April 2018
SF552A-C
Revised Notice

Subject: Medium Duty DD5 A/C Dryer Hardware Updates

Models Affected: Specific Freightliner Business Class M2 model vehicles manufactured February 17, 2016, through December 23, 2016, and equipped with MEDG DD5 engines.

Fig. 3, A/C Refrigerant Line Lower Support Bracket Installation

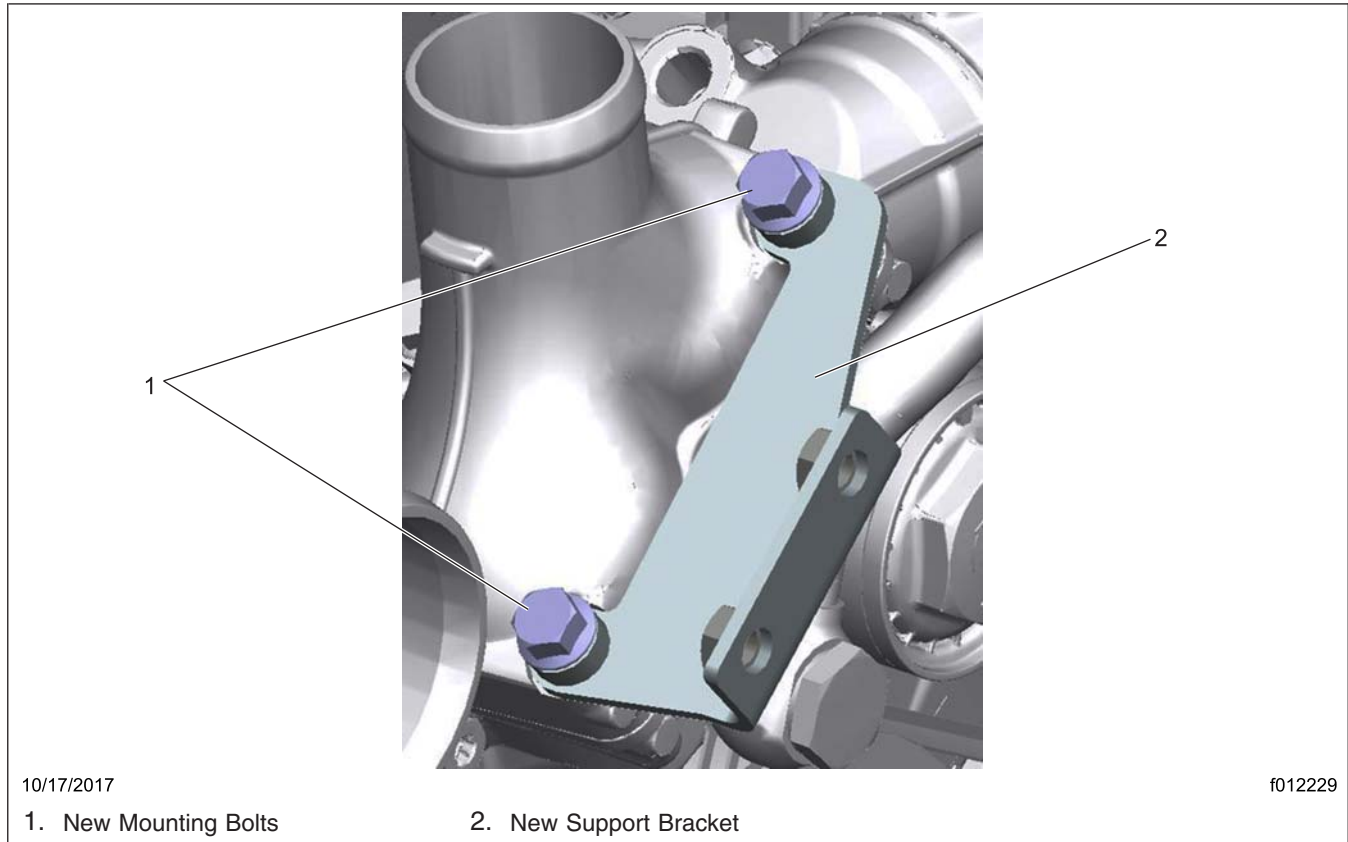
15. Install the new A/C refrigerant line lower support bracket and two new supplied mounting bolts. Hand tighten the bolts. See [Fig. 3](#).

16. Tighten the A/C refrigerant line lower support bracket mounting bolts and the thermostat housing bolt 15 lbf-ft (20 N·m).

Fig. 4, A/C Refrigerant Line Upper Support Bracket Installation

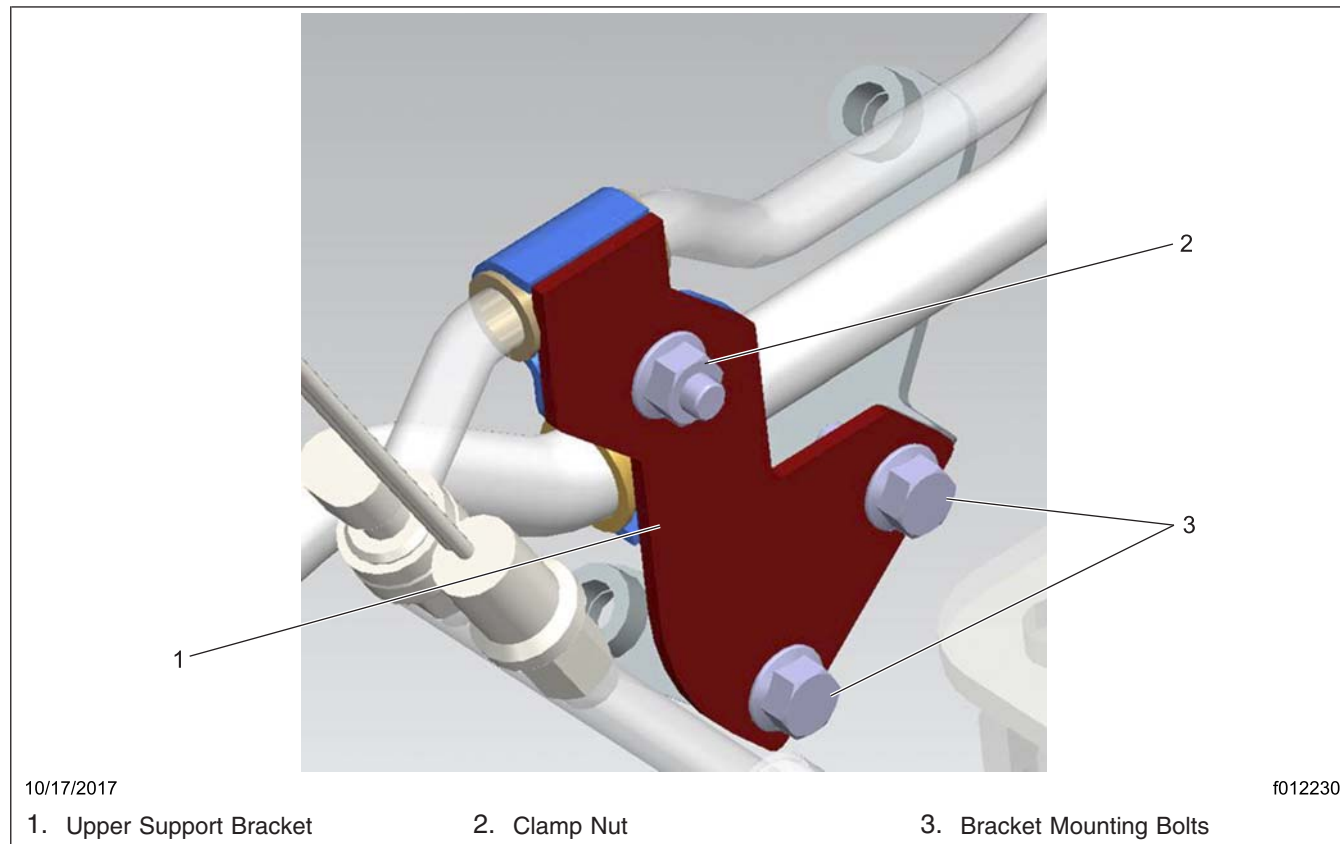
17. Install the new A/C refrigerant line upper support bracket with supplied mounting bolts. See **Fig. 4**. Hand tighten.

18. With the rubber isolators and the bracket in the original location, install the original bolt and nut that secure the A/C refrigerant line clamp to the new A/C refrigerant line upper bracket. Hand tighten the fasteners.
19. Install the upper radiator hose at the thermostat housing.

20. Tighten the A/C refrigerant line upper support bracket mounting bolts and line clamp nut to 15 lbf·ft (20 N·m).
21. Fill the cooling system. Refer to *GHG17 DD5 Workshop (DDC-SVC-MAN-0194)*, **6.3 Cooling System Fill Procedure**.
22. If removed, install the bumper. Refer to the *New Cascadia Workshop Manual*, **Section 31.02**.

Fig. 6, New A/C Dryer Mounting

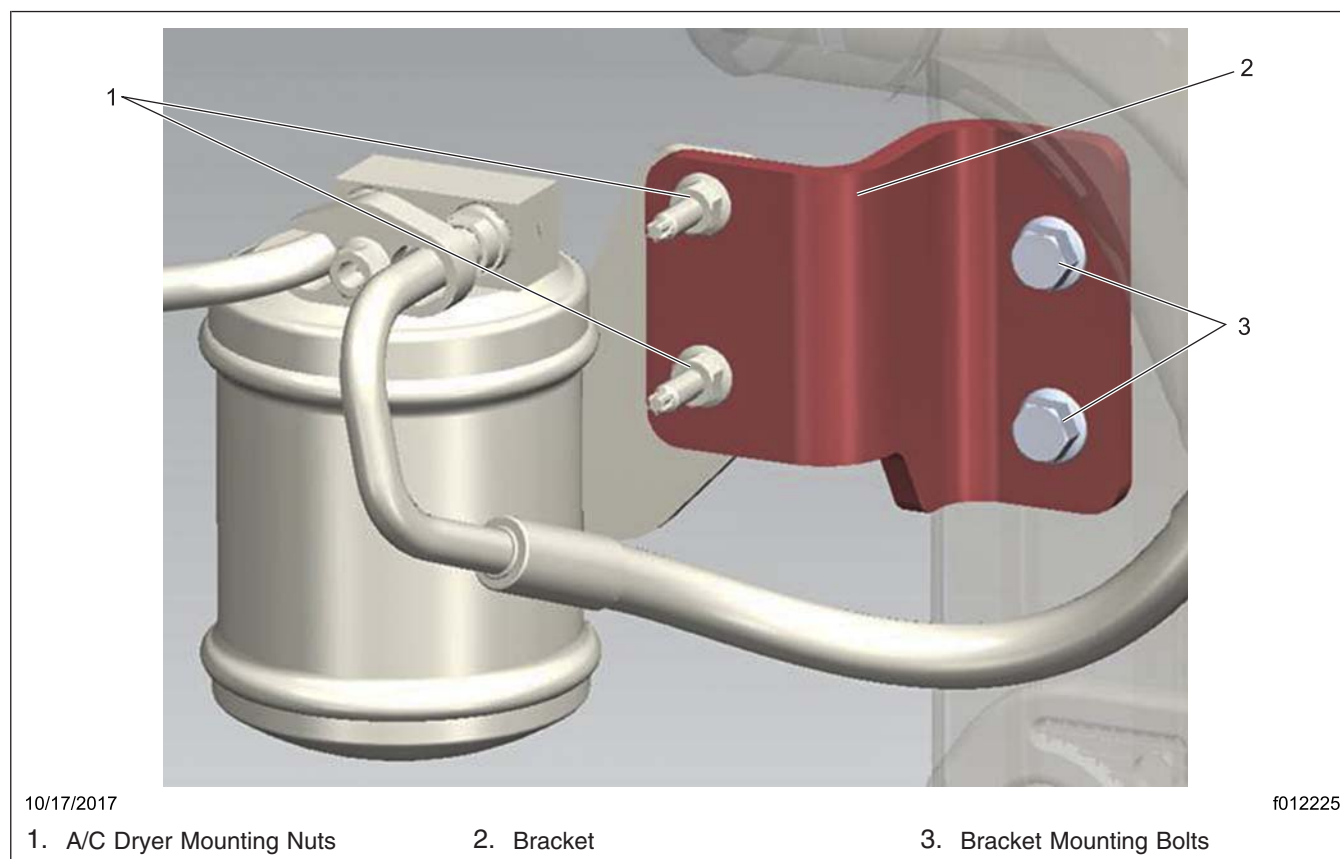
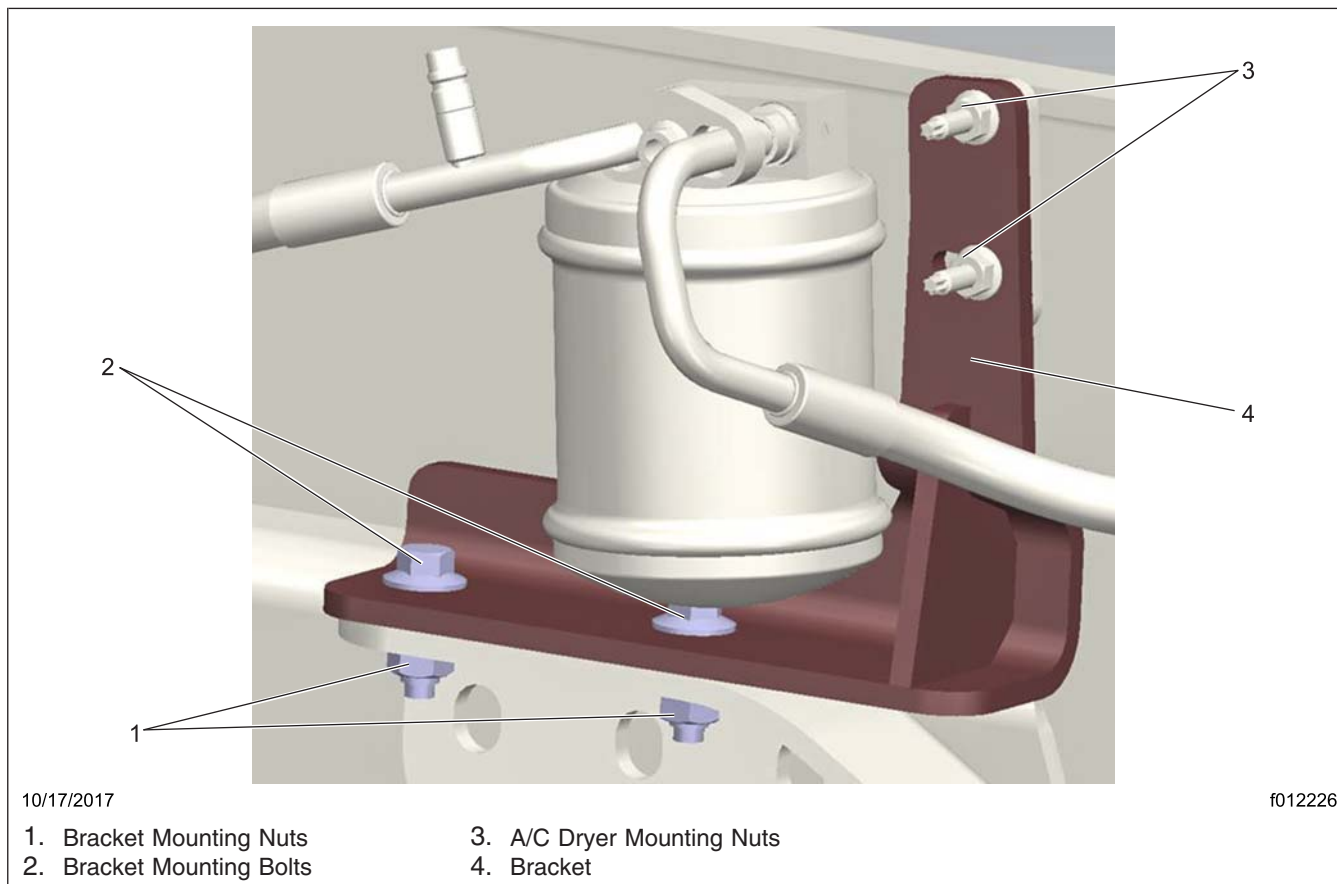
1. Remove the mounting nuts from the A/C dryer and position the A/C dryer aside. Retain the nuts for installation. See [Fig. 5](#).

3. Place the A/C dryer mounting studs through the new A/C dryer bracket while aligning the new A/C dryer bracket to the frame. See **Fig. 6**.

4. Install the new A/C dryer support bracket with the supplied bolts and nuts. Hand tighten the fasteners.
5. With the new A/C dryer bracket installed verify it is mounted parallel with the frame rails, then tighten the fasteners 30 lbf-ft (40 N·m).
6. Install the A/C dryer mounting nuts. Tighten the nuts 15 lbf-ft (20 N·m).
7. Go to "Starter Cable Replacement" following.

Fig. 7, Starter Cable Bracket Installation

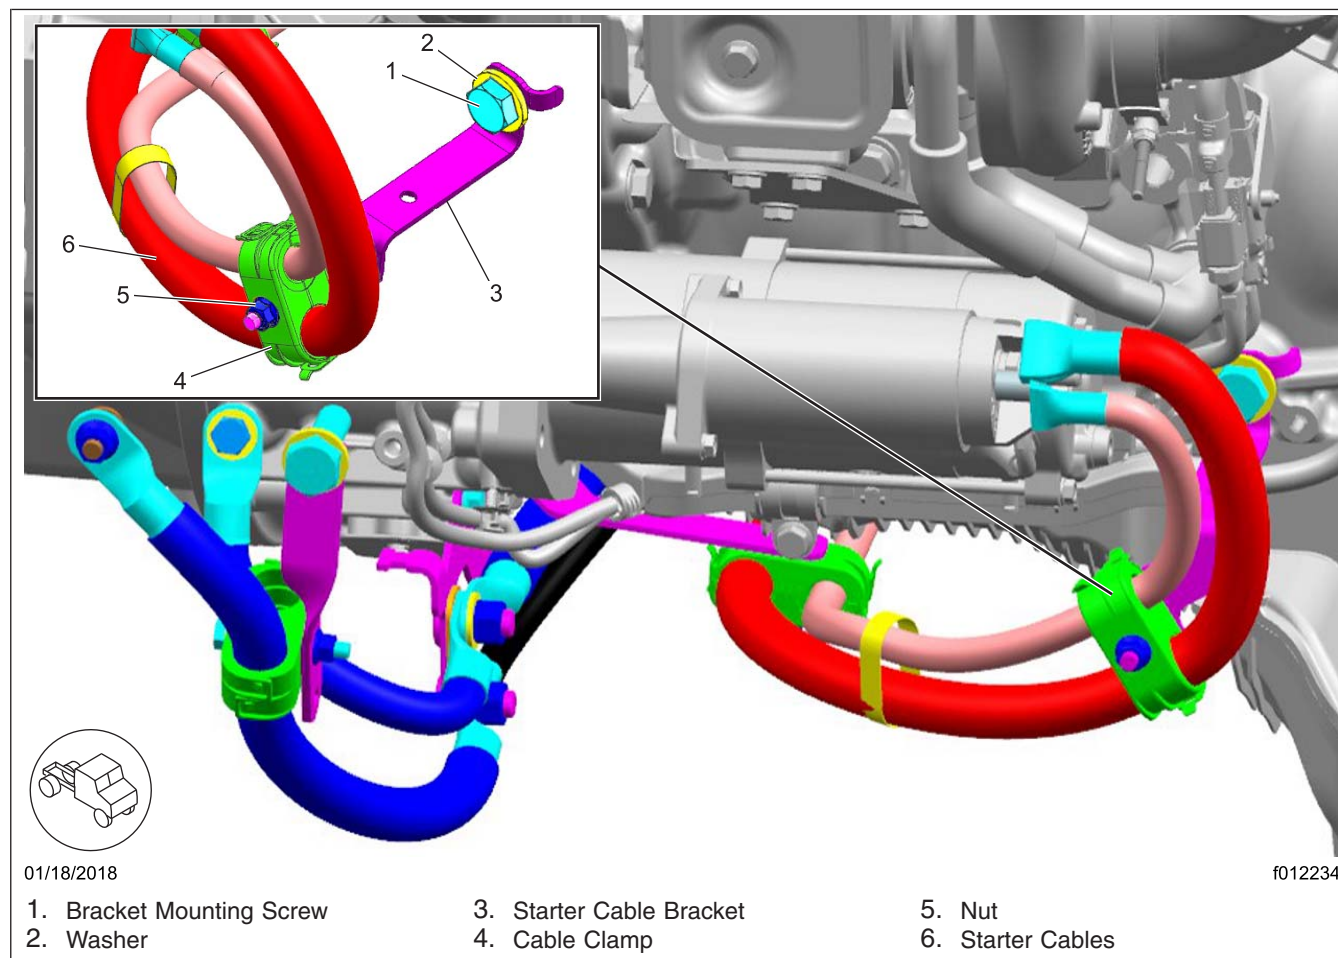
1. With the batteries disconnected, remove the cable clamp from the forwardmost starter-cable bracket. See **Fig. 7**.

2. Remove the forwardmost starter-cable bracket from the engine block.
3. Install the new bracket.
4. Install the cable clamp on the bracket.
